Re: **Opposition to Permit Renewal - New Permit No.: WQ0015010001; Request for Contested Case Hearing**

**Subject:** Abraxas Corporation New Wastewater Permit (#15010-001, TX0133116)  
Discharge to a tributary of Lake Worth (Segment 0807)

Re: Application of Abraxas Corporation for Proposed Permit No. WQ-0015010-001

SPRINGTOWN SE QUADRANGLE  
TEXAS  
7.5-MINUTE SERIES

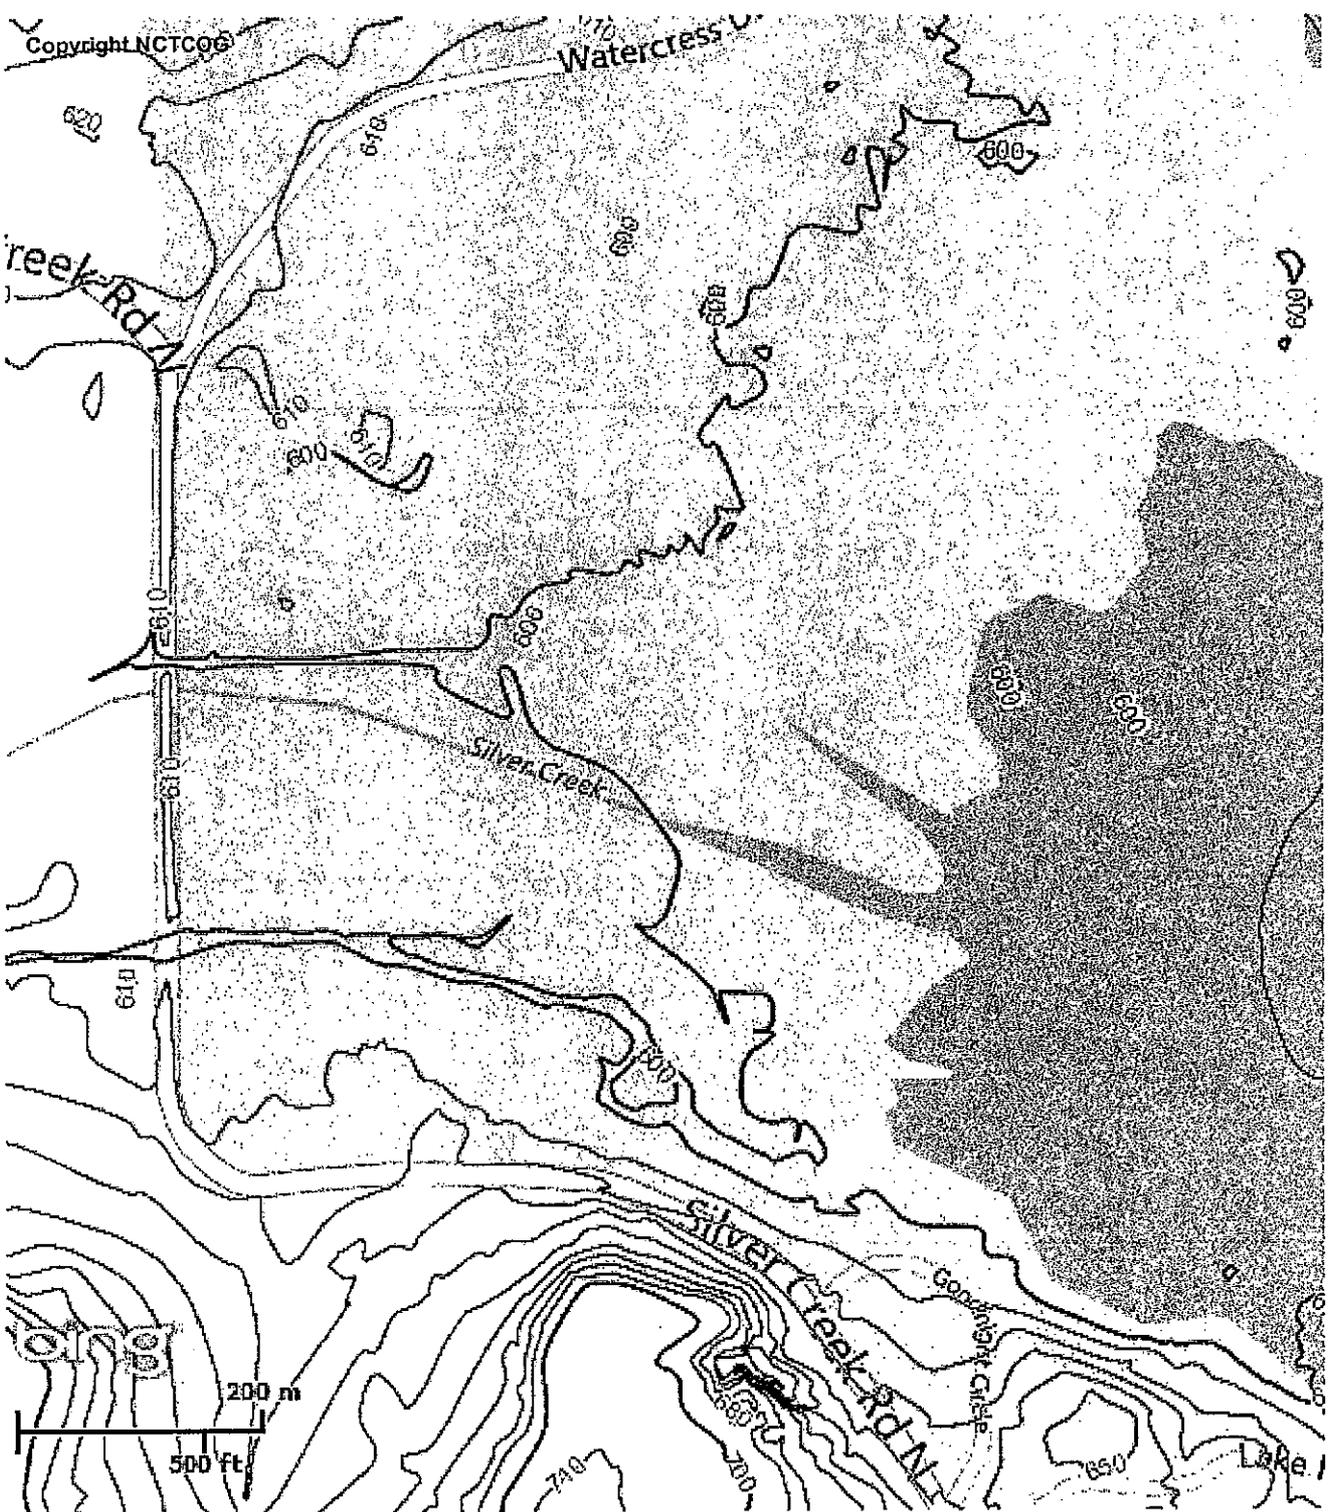
A review of the “new elevation information” submitted by the applicant indicates that the applicant’s engineer merely supplied TCEQ staff with a USGS map with the distances marked from the treatment plant to Silver Creek Road, plus a North Central Texas Council of Governments (NCTCOG) map with contours marked from Silver Creek Road to an approximate Lake Worth pool elevation of 594.0 feet msl. The applicant’s engineer then states cryptically “My distances on the USGS map are from zooming way in and tracing the waterway as plotted. I may have more detail on the meanderings than you would be able to pick up from a paper map.” **Attachment 2** is a copy of the Applicant’s submittal.

Therefore the new information submitted by the applicant does not appear to be a “more detailed and accurate estimate of the distance between this discharge and the normal pool elevation of Lake Worth.” TCEQ staff initially believed that the distance was 5.6 stream miles, then refined that to an estimate of 4.7 stream miles, then again revised that based on the applicant’s contour map submittal to an estimate of 5.4 stream miles. From this record of flip-flopping estimates, it is clear that a hearing is needed to resolve the issue and determine the actual stream mile distance between the wastewater treatment plant discharge point and Lake Worth at a pool elevation of 594.3 feet msl. If the true distance is five stream miles or less, then the permit is required to have effluent discharge limits of 10 mg/l BOD<sub>5</sub>, 15 mg/l TSS, and 4 mg/l DO, plus the use of filtration to supplement suspended solids removal.

I have attached a copy of the USGS map we submitted with the distance from the treatment plant to the confluence with Silver Creek and to the intersection with Silver Creek Road shown. I have also attached a pdf printout of the NCTCOG map with contours shown from Silver Creek Road to Elevation 594. The distance is 2,130 feet.

My distances on the USGS map are from zooming way in and tracing the waterway as plotted. I may have more detail on the meanderings than you would be able to pick up from a paper map.
